FOUNDATION PERMIT

RE: TB-21-83

Farland Circle (NE.S.) S. x Phillips Rd. (a/k/a Builder's Lot 6)

Plot 130D Lot 475

FOUNDATION AS-BUILT
LOT 6 FARLAND CIRCLE
ASSESSORS MAP 130D LOT 475
NEW BEDFORD, MASSACHUSETTS

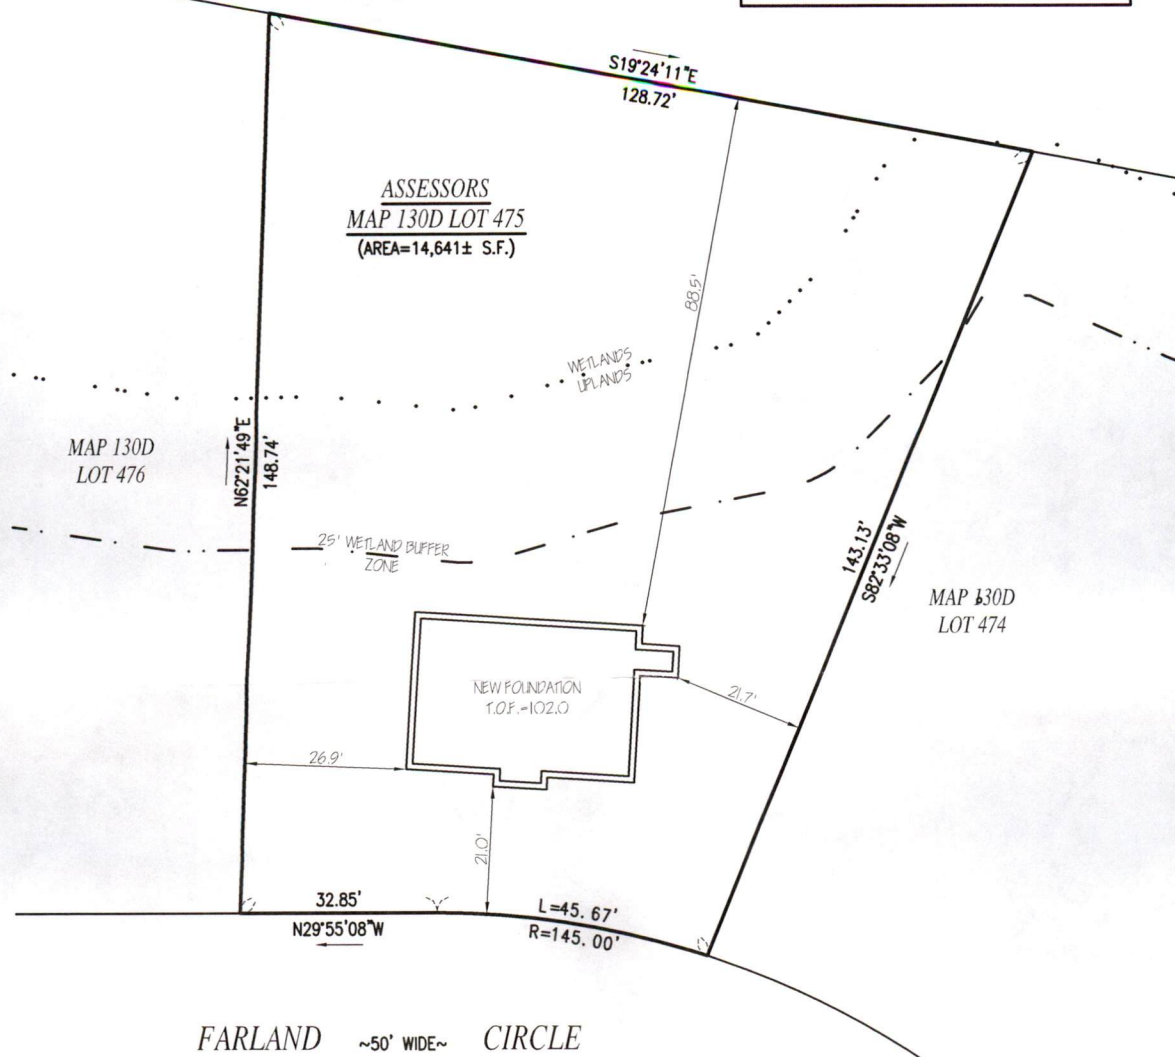
2.) Must provide 1 stamped/signed copy of the "final" site plan approved by DPI for each of the permits being sought (i.e. water, sewer/drain and sidewalk/driveway permits) for the proposed structure. In addition, a copy of the foundation permit (reflecting a new date, since the one issued 2/5/21 by I.S. was reverted) and of the stamped/signed foundation as-built plan must also be submitted.

SITE PLAN
— FARLAND CIRCLE —
ASSESSORS MAP 130D LOT 475
NEW BEDFORD, MASSACHUSETTS

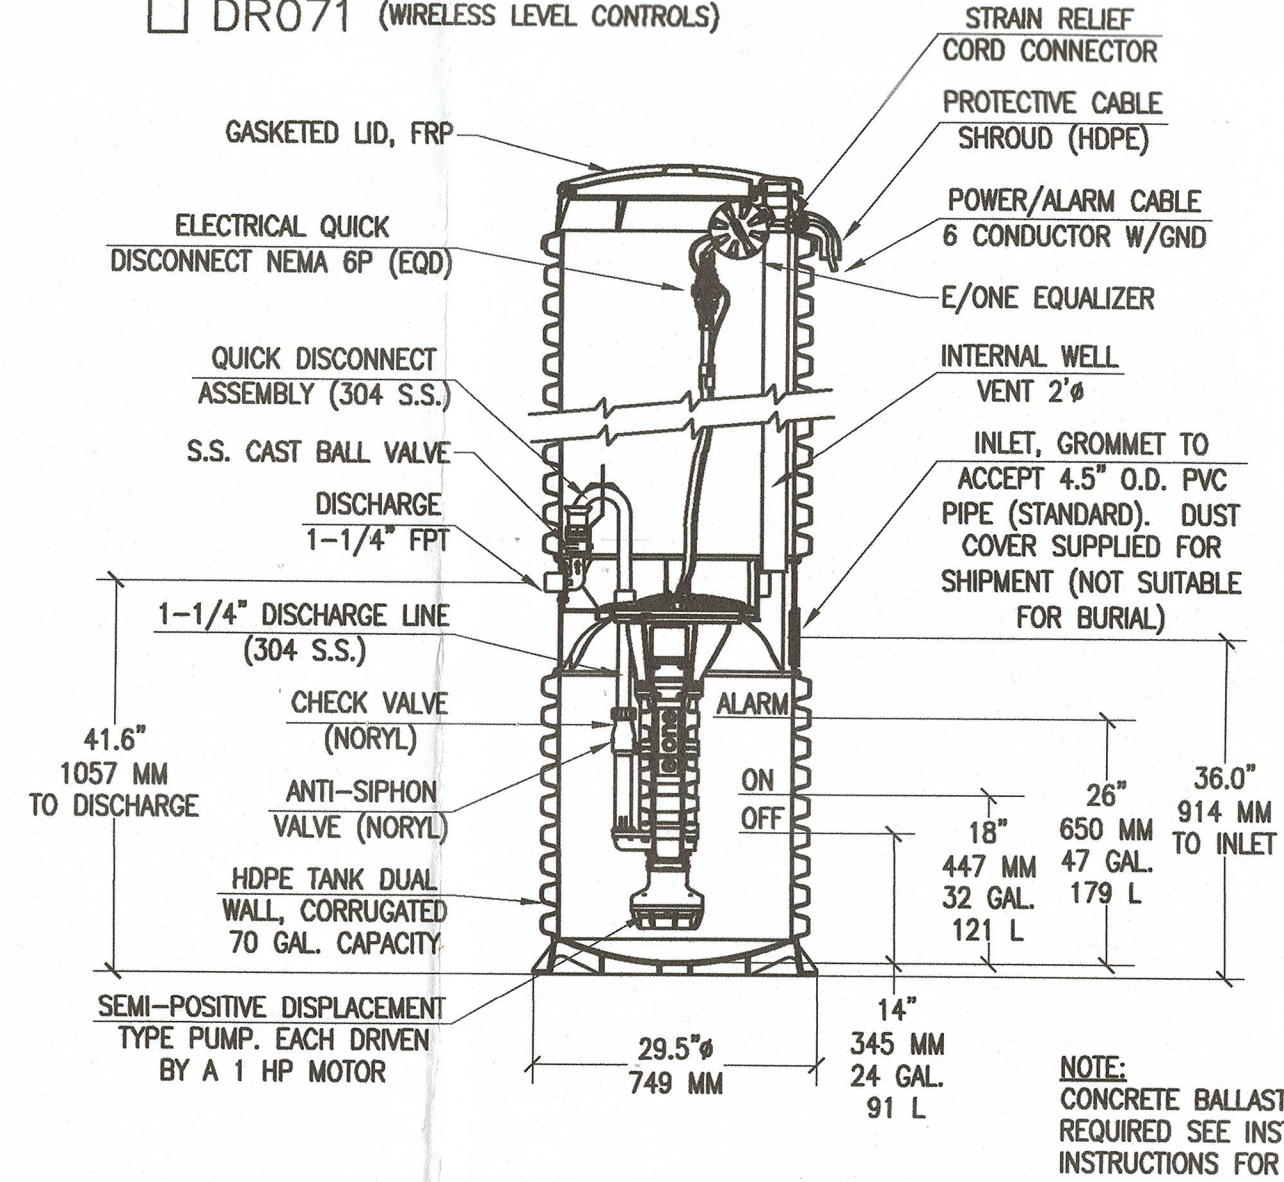
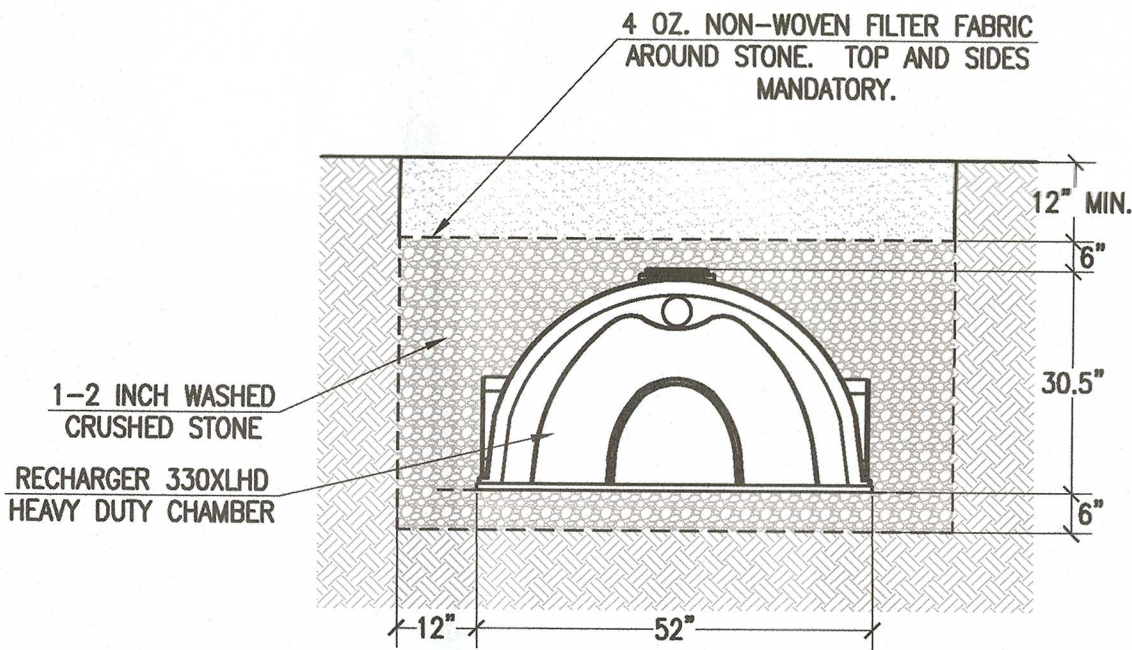
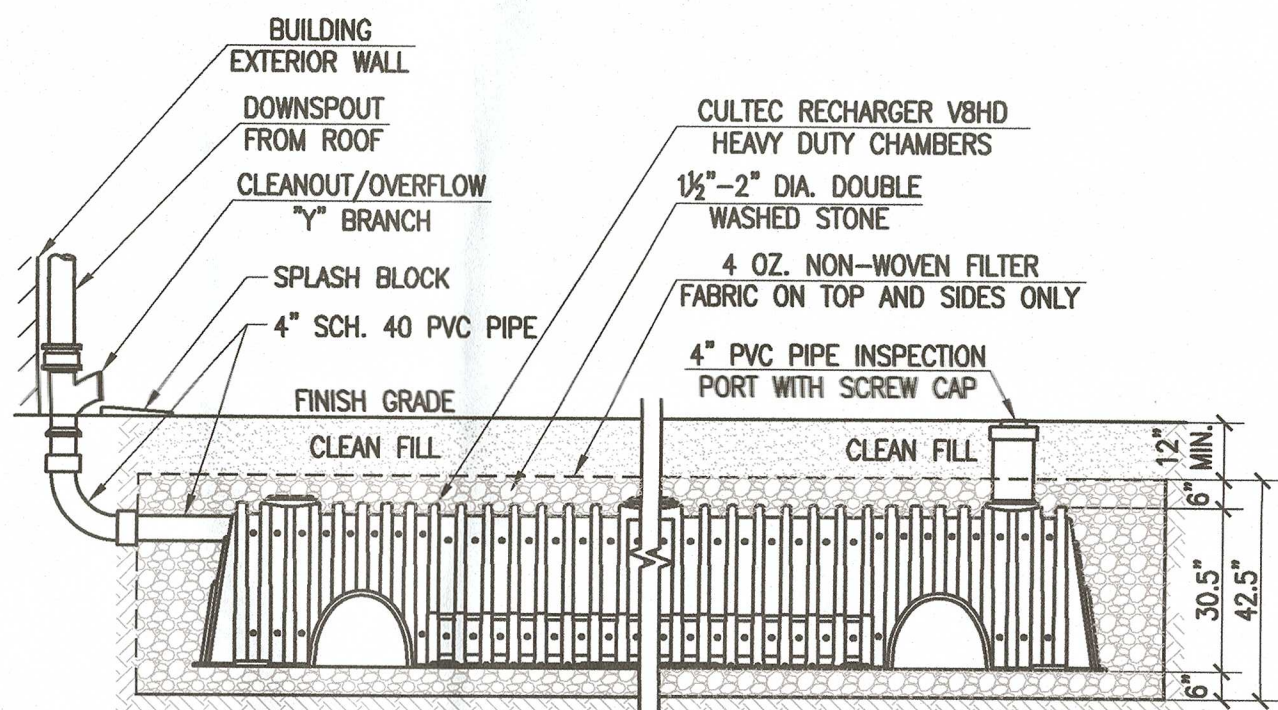
1.) The site plan submitted in View Permit, titled: "Site Plan, Farland Circle, Assessors Map 130D Lot 475, New Bedford, Massachusetts", having a date of 8/17/2020 (last revised 2/4/2021), as prepared by Farland Corp. and stamped/signed by Christian A. Farland, P.E. (Civil), is approved for obtaining DPI permits, with the following comments:

a. The placement of the proposed subsurface roof recharge unit at the rear right corner of the new dwelling was noted to be in close proximity to the wetlands, however, the engineer has stamped this plan certifying that the system will function as proposed.

3.) The site plan submitted indicates that there may be a sump pump tie-in at this location. The recharge system calculations must incorporate sump pump discharge, and the conditions stipulated by the City Engineer regarding sump pump installations will apply, as follows:

a. The sump pump tie in will require a letter stamped and signed by a registered professional engineer in the Commonwealth of Massachusetts along with the supporting calculations and plans stamped and signed by the same engineer documenting the design and standards. These documents are needed before DPI signs off on the CO.

b. A concrete lip should be constructed around the sump pump and pit (6-in high) so that if there is a spill in the basement, it cannot flow into the pit and be pumped to the infiltrator unit thereby contaminated the groundwater and site. This needs to be inspected and

- : 1. Sewer service to be 10 ft away from water service.
- 2. Water service to be perpendicular (90 degrees) from main to property line
- 3. Water curb stop (shut -off) to be 1.5ft from face of curb/pavement.
- 4. Install water meter at point of entry to building
- 5. Owner to apply for water and sewer permits.
